APPLICATION NO.	FILING DATE	FIRST NAMED INVENTOR	ATTORNEY DOCKET NO.	CONFIRMATION NO.
10/551,680	09/29/2005	Keigo Nagao	930055-2036	5620
7590	11/02/2006			
Ronald R Santucci Frommer Lawrence & Haug 745 Fifth Avenue New York, NY 10151			EXAMINER ROSENAU, DEREK JOHN	
			ART UNIT 2834	PAPER NUMBER

Office Action Summary	Application No. 10/551,680	Applicant(s) NAGAO ET AL.	
	Examiner Derek J. Rosenau	Art Unit 2834

DETAILED ACTION

Figure A

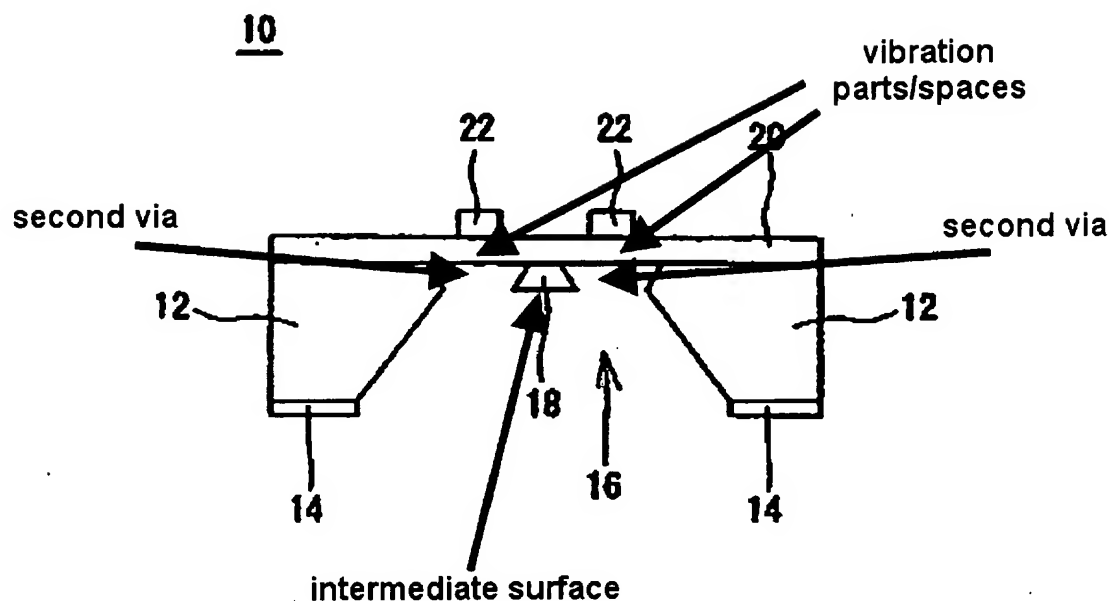
5. With respect to claim 1, Masaki et al. discloses a piezoelectric thin film device (Fig 2) comprising a substrate (item 12) having a vibration space (see Figure A below), and a piezoelectric laminated structure (item 22) formed on an upper surface side of the substrate, the piezoelectric laminated structure including a piezoelectric film and electrodes formed respectively on both surfaces of the piezoelectric film (Paragraph 2), and the vibration space being formed so as to allow a vibration part to vibrate (Paragraph 8), the vibration part including at least a part of the piezoelectric laminated structure (Fig 2), wherein the vibration space is constituted by a first via hole (item 16) formed from a lower surface of the substrate toward an upper surface thereof with an intermediate surface (see Figure A below) formed at an intermediate position in the substrate, and a second via hole (see Figure A below) formed from the intermediate surface toward the upper surface of the substrate, the second via hole being positioned inside the first via hole when viewed in a vertical direction (see Figure A below).

6. With respect to claim 2, Masaki et al. discloses the piezoelectric thin film device as claimed in claim 1, wherein plural vibration parts each being the vibration part are formed on the upper surface side of the substrate (Fig 2), the first via hole is formed so as to share a part of each of vibration spaces respectively for the plural vibration parts (Fig 2), and plural second via holes each being the second via hole are formed from the intermediate surface (see Figure A above), so as to correspond respectively the plural vibration parts (see Figure A above).

8. With respect to claim 5, Masaki et al. discloses a method for manufacturing a piezoelectric thin film device (Fig 2) of claim 1, wherein when the vibration space in the substrate is formed, a first via hole is formed from a lower surface of a substrate toward an upper surface thereof (Fig 3K), so as to form a bottom surface of the first via hole at an intermediate position in the substrate (Fig 3K), a second via hole is thereafter formed from the bottom surface toward the upper surface of the substrate material (Figure 3L), to be positioned inside the first via hole when viewed in a vertical direction (Fig 3L or Fig 2), and the intermediate surface is formed by such a part of the bottom surface that remains in the substrate material (see Figure A above).

9. With respect to claim 6, Masaki et al. discloses the method as claimed in claim 5, wherein the piezoelectric thin film device has plural vibration parts each being the vibration part (see Figure A above), on the upper surface side of the substrate (see Figure A above), the first via hole is formed to be shared by the plural vibration parts (See Figure A above), plural second via holes being the second via hole are formed from the bottom surface, so as to correspond respectively to the plural vibration parts (see Figure A above).

surface of the substrate and the piezoelectric laminated structure (Fig 2), the vibration part includes a part of the insulating layer (See Figure A above). Masaki et al. does not disclose expressly that the insulating layer has a thickness of .3 μm to .5 μm . However, it has long been held that the mere change in size of a device is obvious. Therefore, at the time of invention, it would have been obvious to a person of ordinary skill in the art to change the thickness of the insulating layer such that it between .3 μm and .5 μm .
